SEASTAR/BAYSTAR NYLON TUBING LOT# 71335 AND 71336

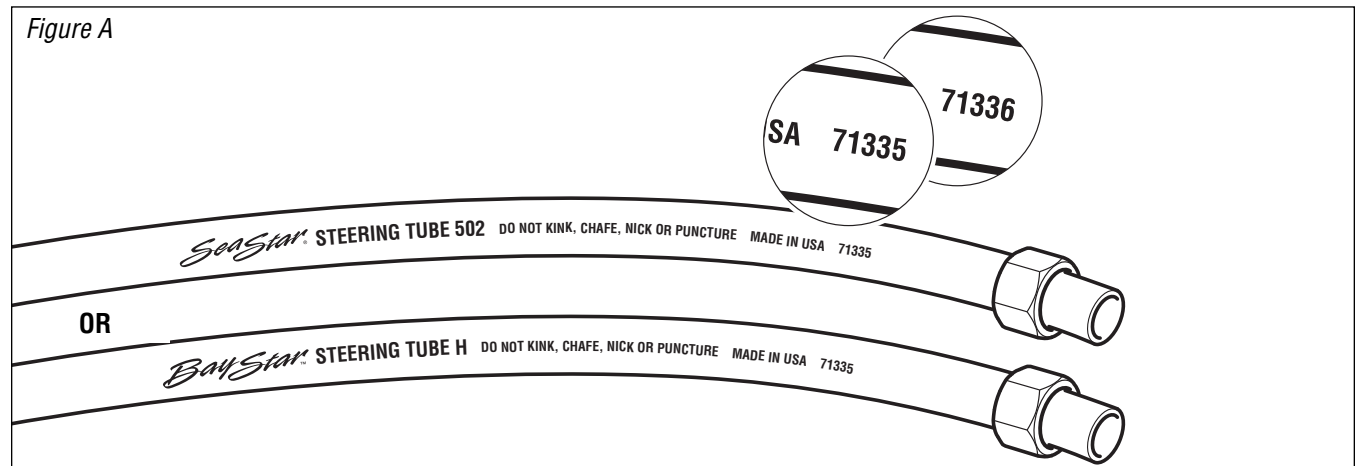
Locate the 'lot number' on the SeaStar/Baystar Nylon Tubing. (Refer to figure A.) Check **ALL** tubing on board your boat for this Lot number. If your tubing is **NOT** marked Lot# '**71335**' or '**71336**', or is marked with a different number, please go to Step 3.

If any of your boats tubing is marked with Lot# '**71335**' or '**71336**' (refer to figure A), this tubing must be removed and replaced prior to your boats next use. Please contact our **Warranty Department toll free at 1-866-779-6899** for replacement parts.
